ITEM 28  
MANAGER'S REPORT NO. 43  
COUNCIL MEETING June 10/74

Re: Letter from Mr. M. Kinoshita, 1050 Augusta Avenue and  
Mr. R. M. Peterson, 1070 Augusta Avenue  
Piping Watercourse  
(Item 16, Report No. 33, April 29, 1974)

TO: MUNICIPAL MANAGER 5 JUNE, 1974  
FROM: DIRECTOR OF PLANNING  
RE: WATERCOURSE ENCLOSURE  
SUBDIVISION REFERENCE #9/74 - D.L.135

TO: MUNICIPAL MANAGER JUNE 6, 1974  
FROM: MUNICIPAL ENGINEER  
RE: WATERCOURSE ENCLOSURE SUBDIVISION, REF. #9/74 - D.L. 135.

S.D. 9174

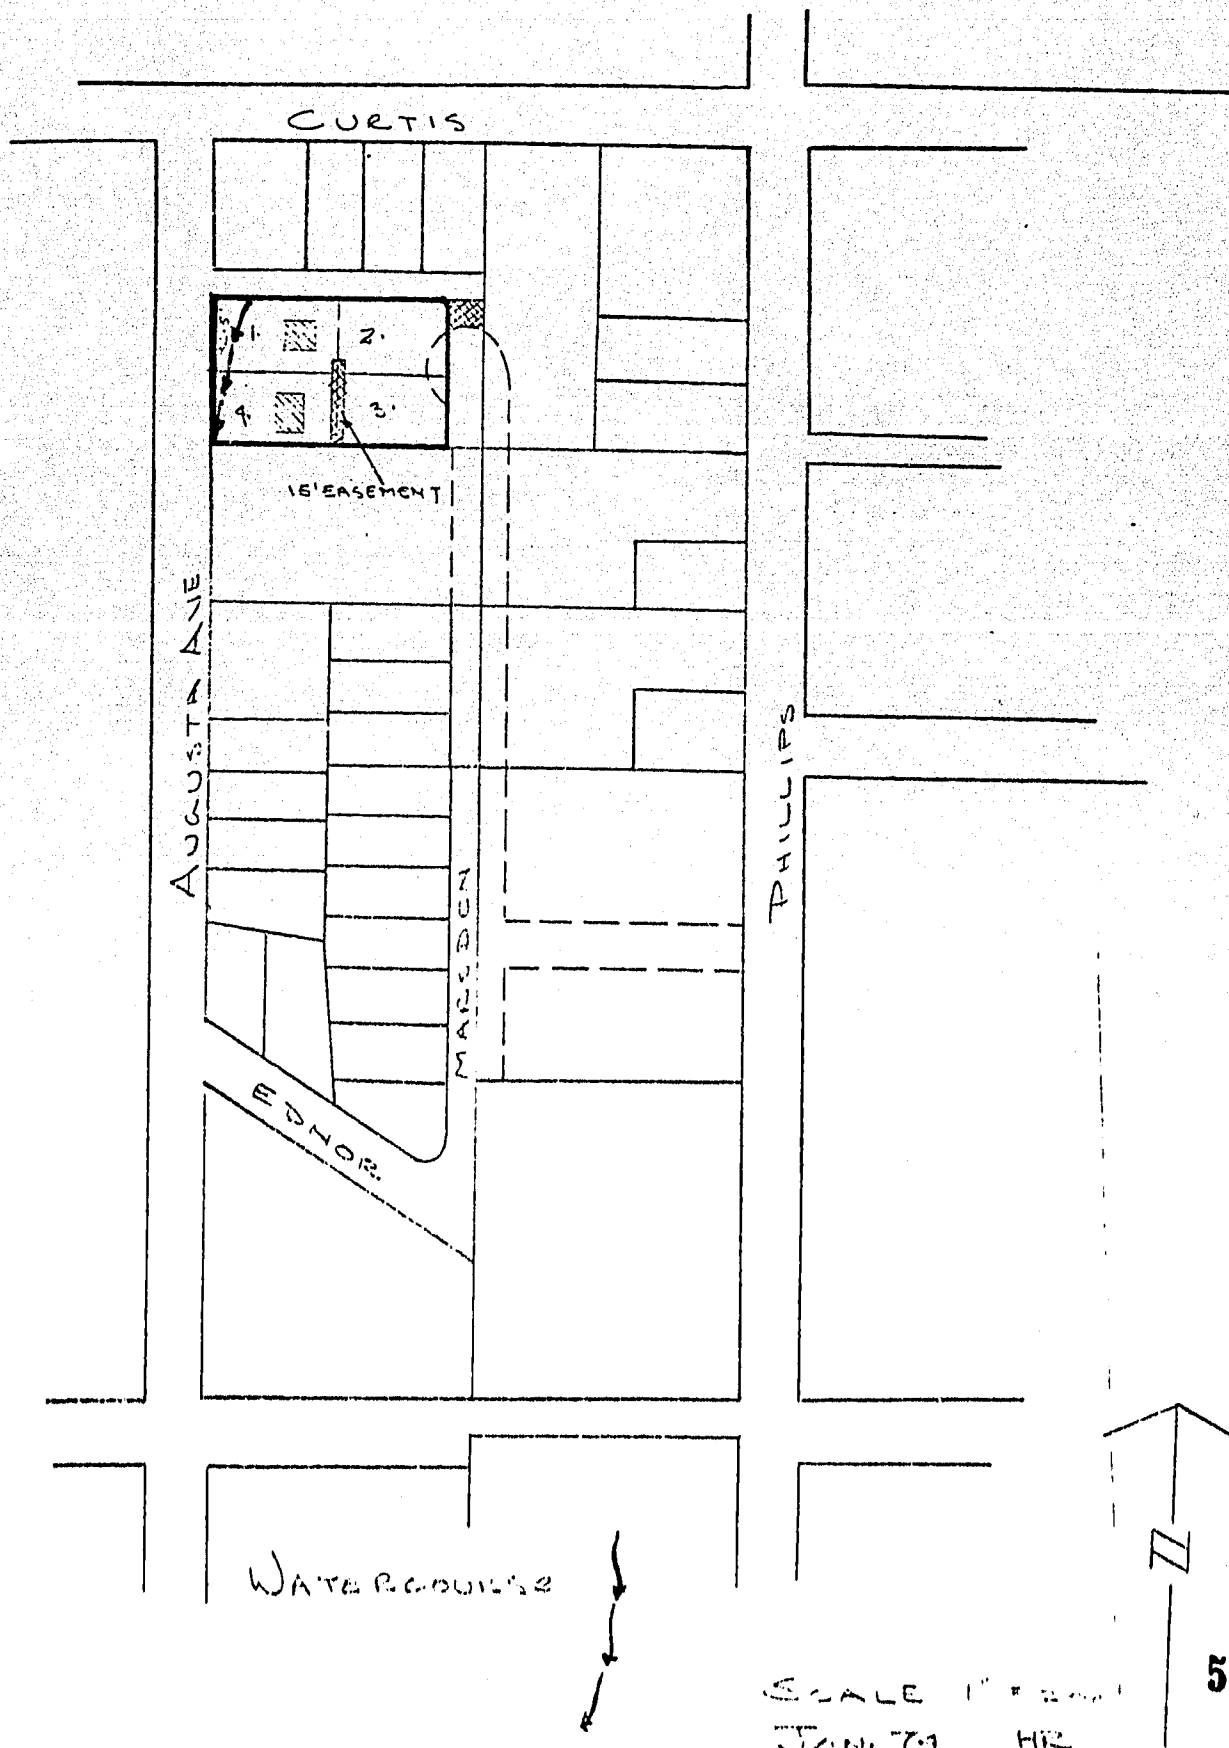
On April 29, 1974 the Planning Department submitted a recommendation to Council that the watercourse traversing the above noted subdivision, (see sketch), be retained in an open condition. It was a condition of the subdivision that the developer be responsible for lining and improving the channel as approved by the Municipal Engineer. The watercourse has an aesthetic value and there are several mature trees located in the front yard which would have had to be removed if the watercourse were piped. Due to the above considerations Council approved the retention of the watercourse in an open improved condition. The subdivision was subsequently approved and registered based on this decision.

The owners of the lots containing the watercourse have submitted a proposal (see attached letter) calling for the piping of the channel which they state the developer is prepared to do. The reasons for piping the watercourse as stated in their letter to the Municipality, i.e., danger, flooding, maintenance and aesthetics, could possibly be valid if the watercourse were to remain as it exists, however the lining and channelization to be carried out by the developer will render these problems non-existent. Due to the above, it is again recommended by the Planning Department that the watercourse be retained in an open improved condition.

It is recommended THAT Council reaffirm an earlier decision to retain the subject watercourse in an open improved condition.

CHANNEL LINING

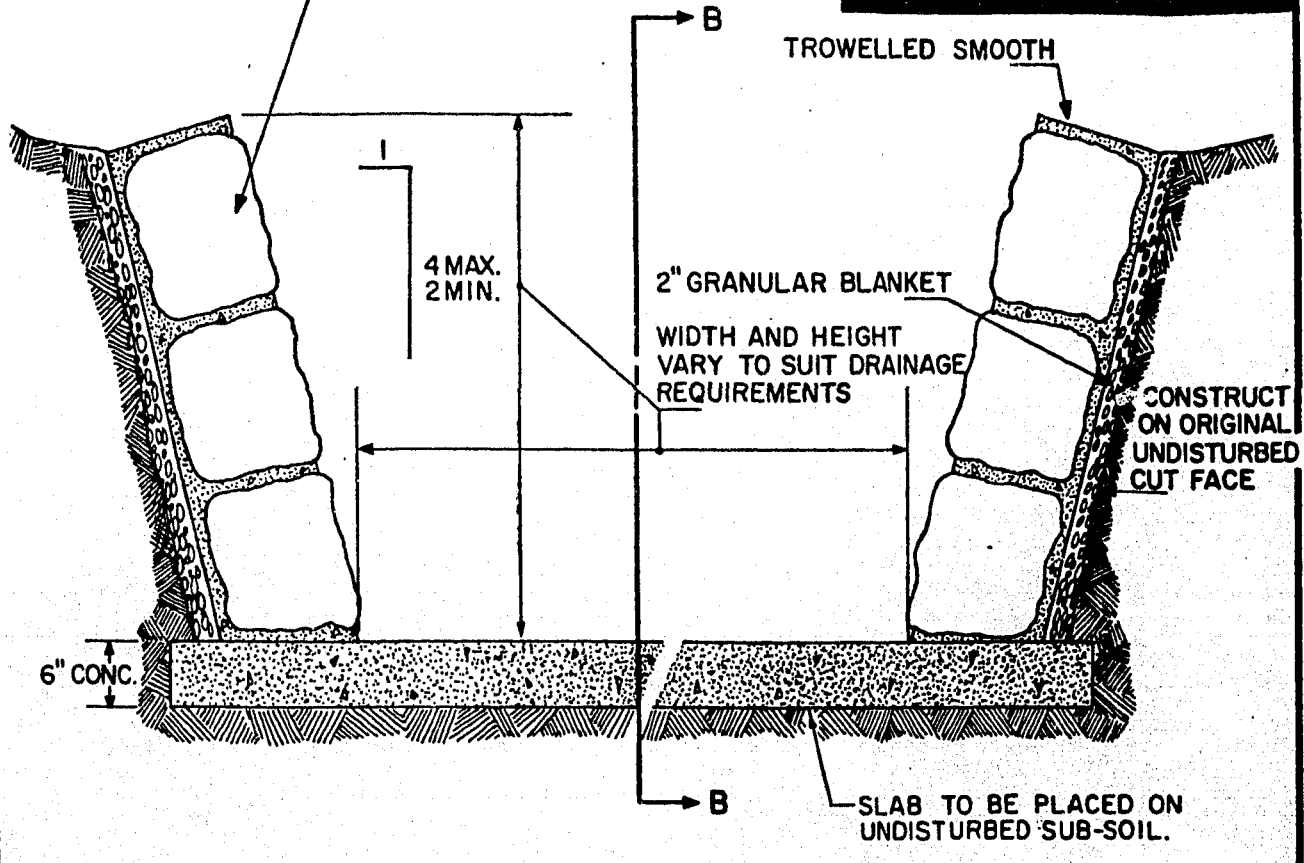
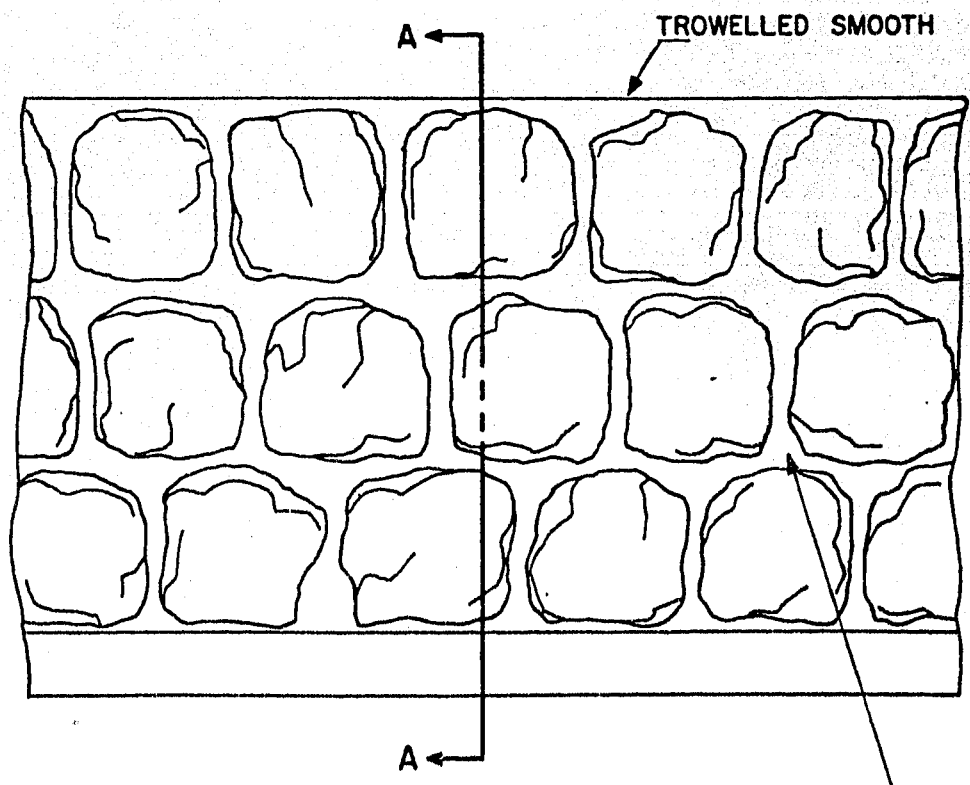
With respect to heavy flows in the creek, the developer's consulting engineer has designed a fully lined open channel as per the Corporation's approved standard (see attached Dwg. No. L 1504). This design is based on standard design criteria and has been sized to adequately handle a 10-year storm plus a one foot freeboard, which will provide a safety factor of approximately 50%. A field check of the site reveals that, should a flooding condition arise, the first properties to be affected would be the front yards and the street boulevard immediately to the south of the subject properties. This is somewhat hypothetical at this time because the subdivision to the south has not been developed and if the front of the properties is filled, then the flooding would be directed onto the roadway.

With respect to the question of creating pools for stagnant water to collect we would advise that the channel lining will eliminate the cause of pools inasmuch as the channel will have a smooth floor constructed at a constant grade.

THAT the Council reiterate its approval given in Item 16, Manager's Report #33, Council Meeting April 29, 1974 at which time it was approved that the watercourse be retained in an open channel, and,
